The BULLETIN OF THE BEAUX-ARTS INSTITUTE OF DESIGN

THE BULLETIN OF THE
BEAUX-ARTS INSTITUTE OF DESIGN
OCTOBER 1944 VOL. XX NUMBERS THREE & FOUR SCHOOL YEAR 1943-1944

DEPARTMENT OF ARCHITECTURE — 1943-1944 — FIFTY-FIRST SCHOOL YEAR

CLASS A PROBLEM V—A STATE SUPREME COURT BUILDING

W J MC NEIL
A BUS STATION
CLASS "D" DROPS 22
UNIV & NOTRE DAME

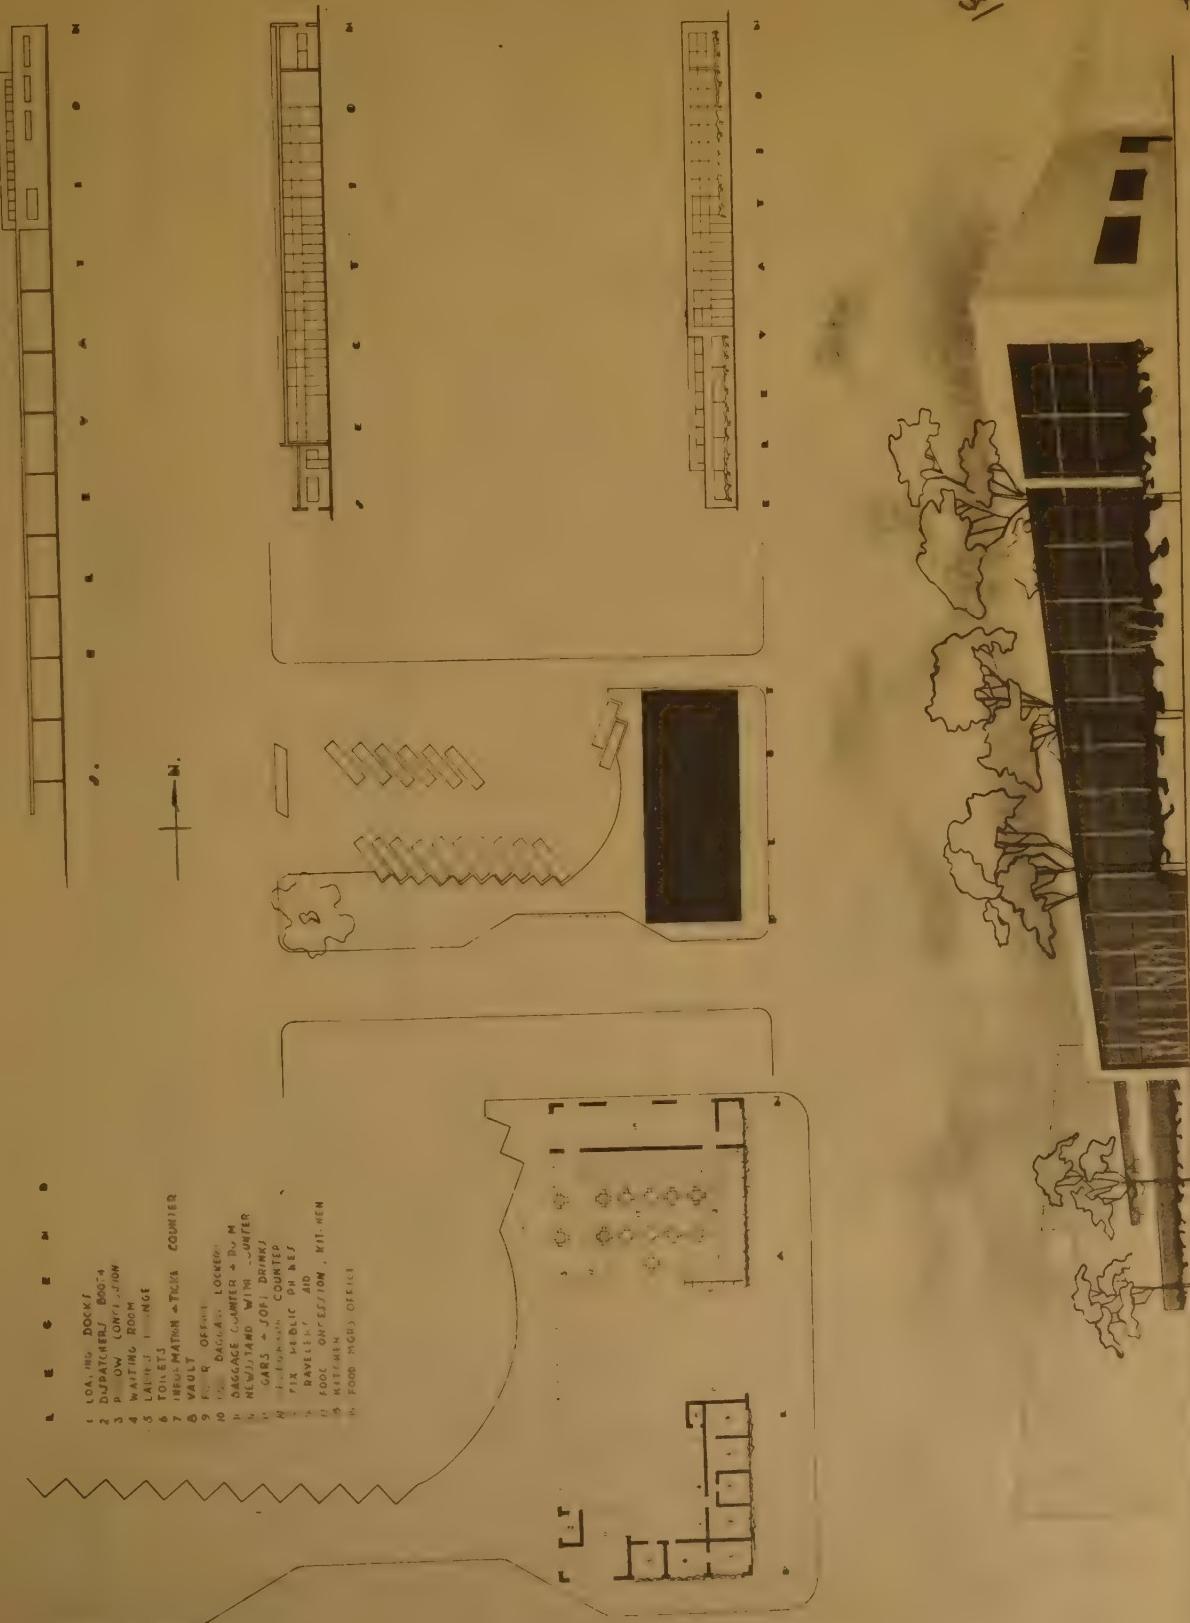
THIS LAST CRITICISM ALSO APPLIES TO THE DESIGN SUBMITTED BY W.J. MCNEIL, UNIVERSITY OF NOTRE DAME - FIRST MENTION. HIS RESTAURANT, WHICH OVERLOOKS BOTH THE BUS DOCKS AND COURT HOUSE SQUARE, IS BETTER HANDLED THAN THE ONE IN THE PREVIOUS DESIGN. ALL THE PLAN FUNDAMENTALS ARE WELL ARRANGED.

HENRY C. KLUCK
UNIVERSITY OF ILLINOIS
CLASS 'C' PROBLEM
A CHILDREN'S
LIBRARY & MUSEUM

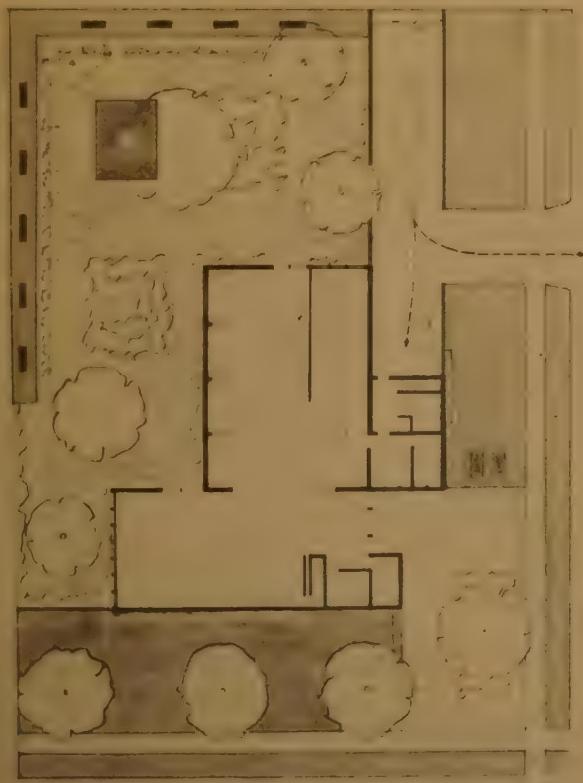
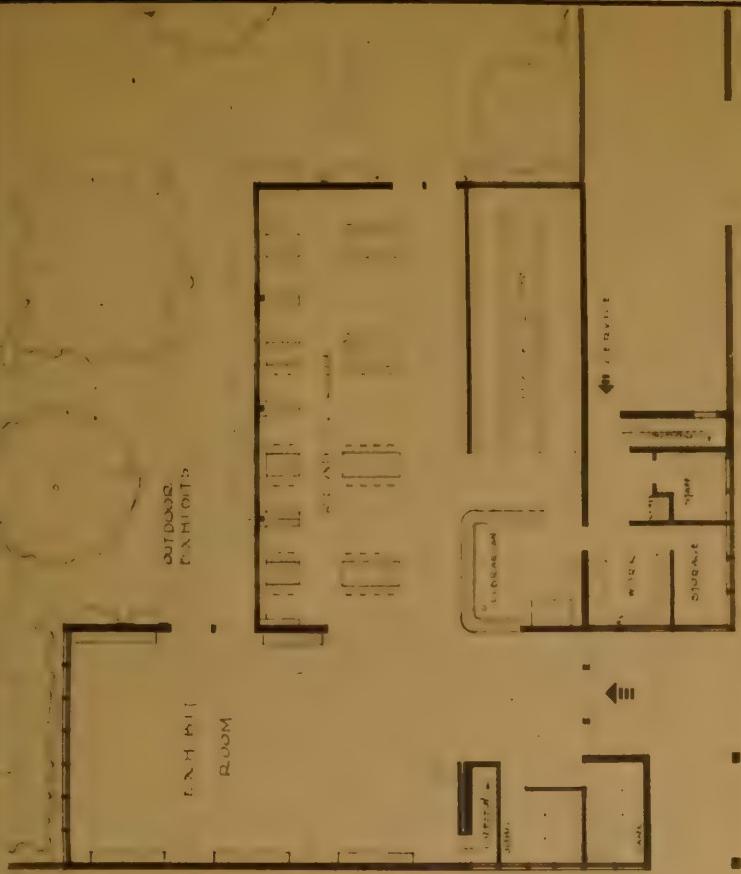
FIRST MENTION - H.C. KLUCK, UNIVERSITY OF ILLINOIS: SIMPLE AND UNIFIED IN PLAN. A QUESTION WAS RAISED, HOWEVER, AS TO THE WISDOM OF PLACING THE READING TABLES NEXT TO THE MUSEUM WITHOUT SCREEN OR TRANSITION EVEN THOUGH IT IS VERY DESIRABLE TO GIVE BOTH THE MUSEUM AND READING ROOM NORTH LIGHT. SUCH AN ARRANGE-

JOHN J. BAILLIE JR. CDR
MARINE PROBLEMS
A MARINE ENGINEER AND
SHIPBOARD PERSONNEL OCT 34

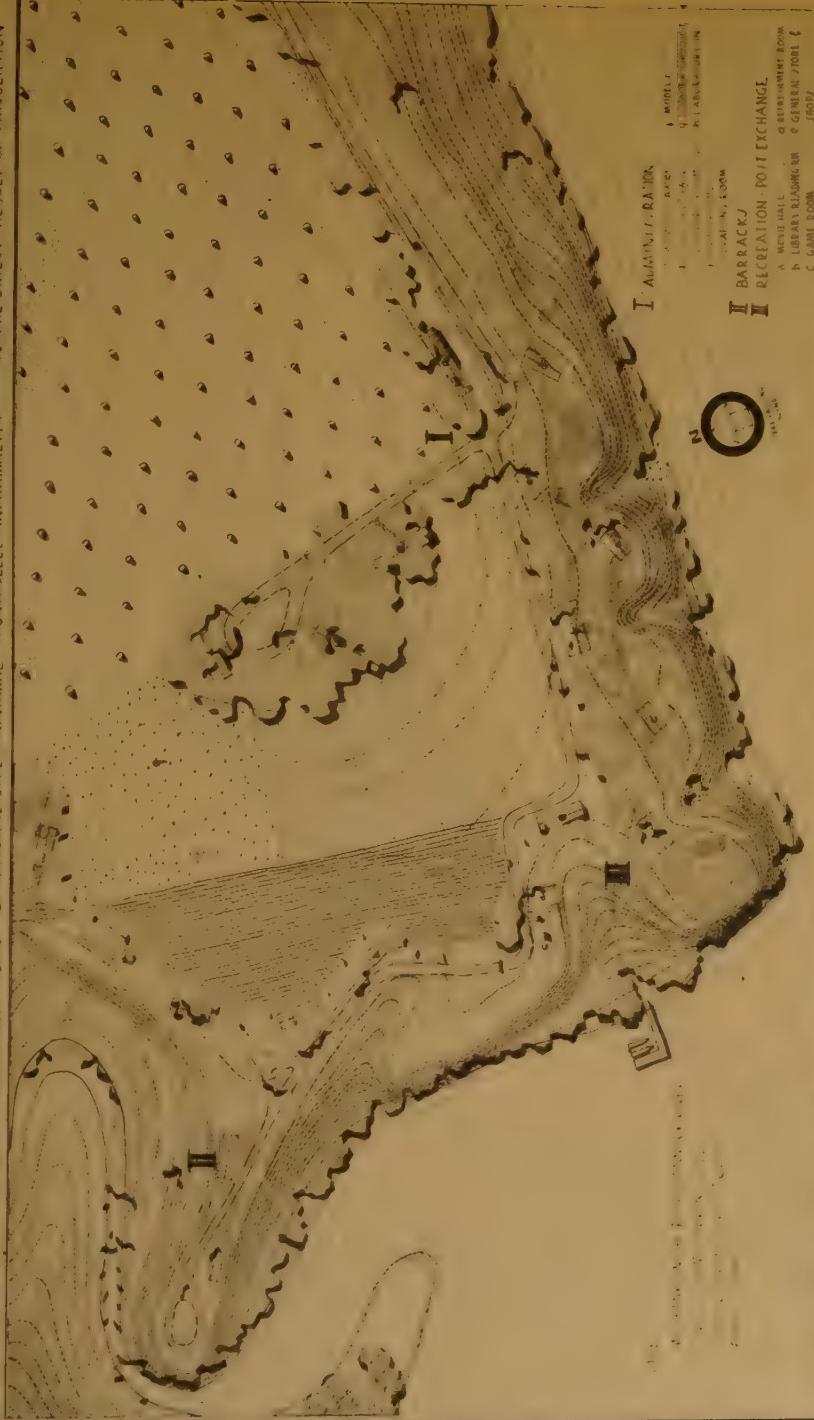
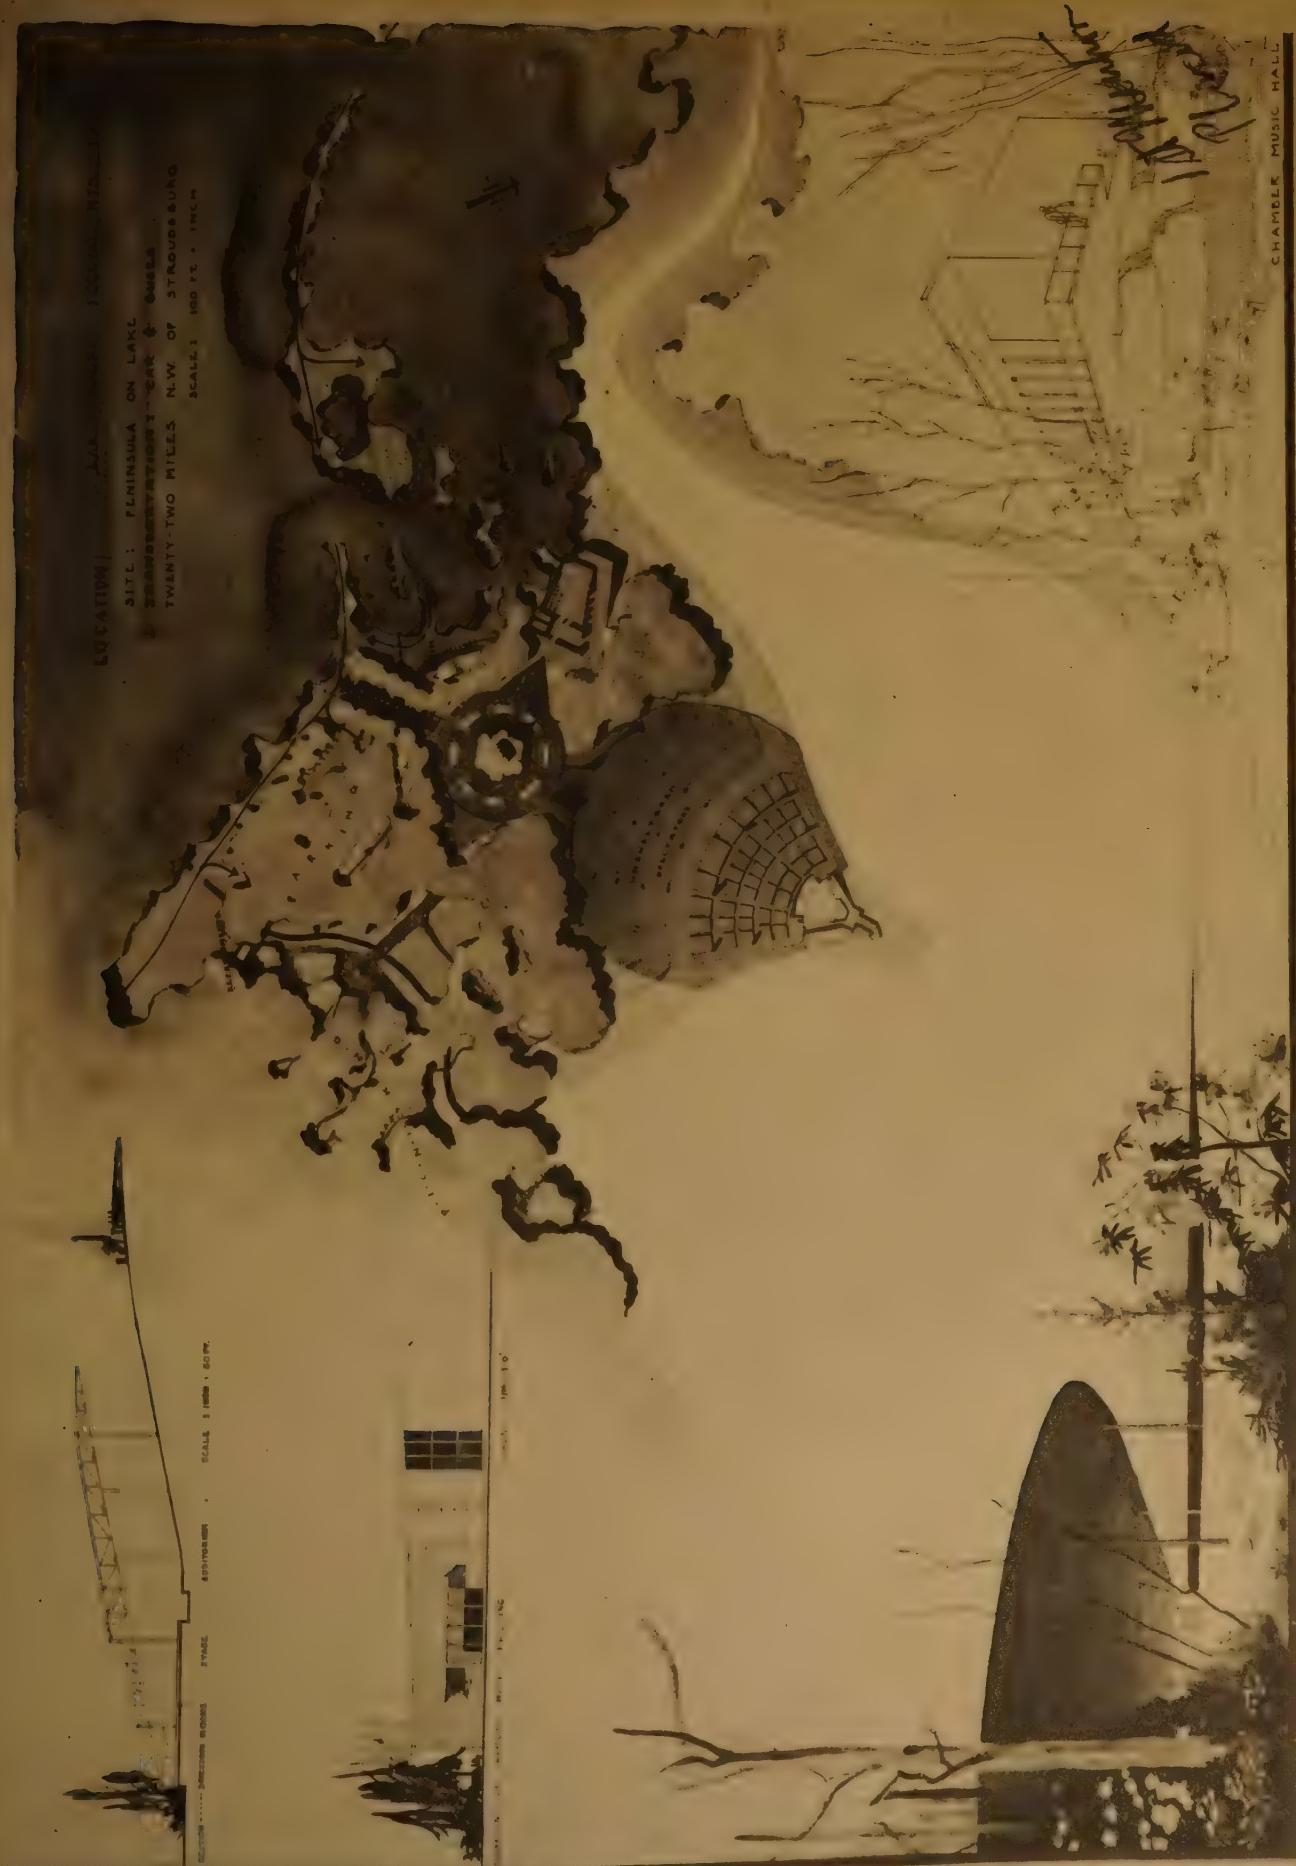
J.J.BALLENTINE, JR., UNIVERSITY OF PENNSYLVANIA - SECOND MEDAL: THIS SOLUTION SHOWS PARTICULAR MERIT IN ITS CHOICE OF A SITE SO TYPICAL OF THE REGION AND SO LACKING IN IDENTIFYING FEATURES THAT IT WOULD BE HARD TO LOCATE. THE PLACEMENT OF THE BUILDINGS IN RELATION TO THE NATURAL FEATURES OF THE LANDSCAPE IS EXCELLENT. HOWEVER, THE JURY QUESTIONED WHETHER THE BUILDINGS COULD BE AS COMPLETELY CONCEALED BY THE BRANCHES OF THE TREES AS THE RENDERING WOULD INDICATE. THIS WOULD BE PARTICULARLY TRUE DURING THE WINTER. THE INTERIORS REVEAL VERY PLEASANT AND LOGICAL, DIRECT SOLUTIONS OF THE BUILDINGS THEMSELVES.

EDWARD COLIN
UNIV. OF ILLINOIS
CLASS 'C' PROB VII
.A ROADSIDE
BASKET SHOP AND
DISPLAY STAND.

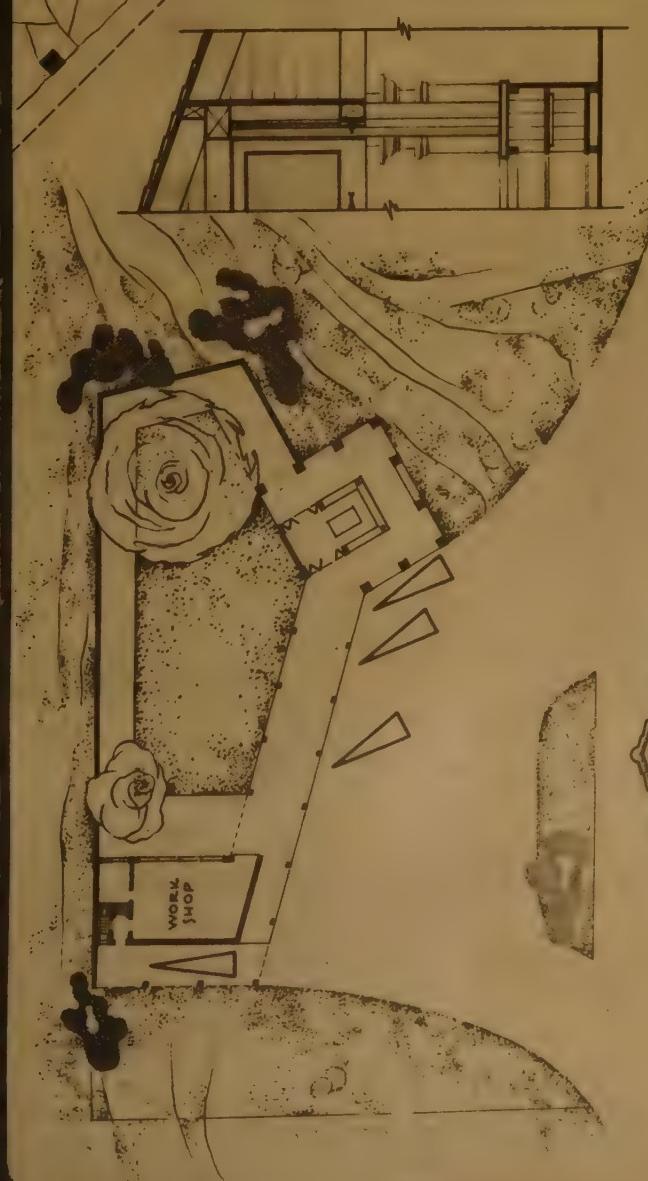
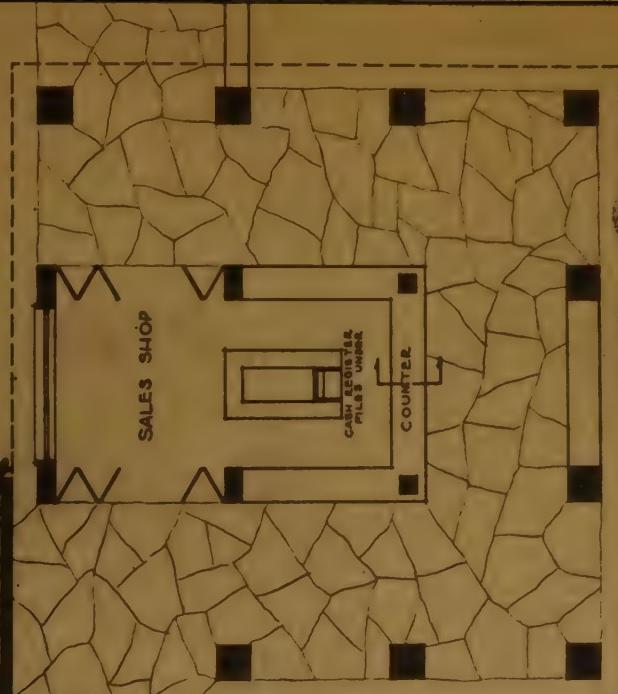
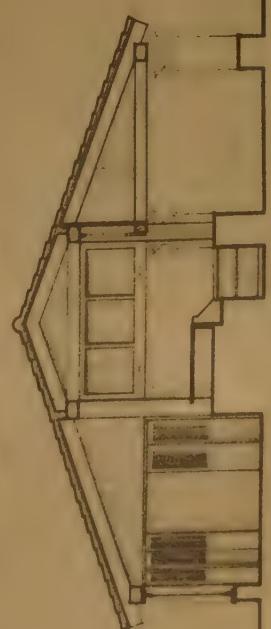
E.COLIN, UNIVERSITY OF ILLINOIS,- FIRST MENTION PLACED, HAD A LOGICAL PLAN WHICH TOOK ADVANTAGE OF THE ENTIRE PLOT. HIS PARKING WAS WELL HANDLED AND THE PROBLEM AS A WHOLE HAD THE GRACE OF CAREFUL ATTENTION. HOWEVER, HE MISSED A TRICK-IN FAILING TO FEATURE THE BASKET DISPLAY.
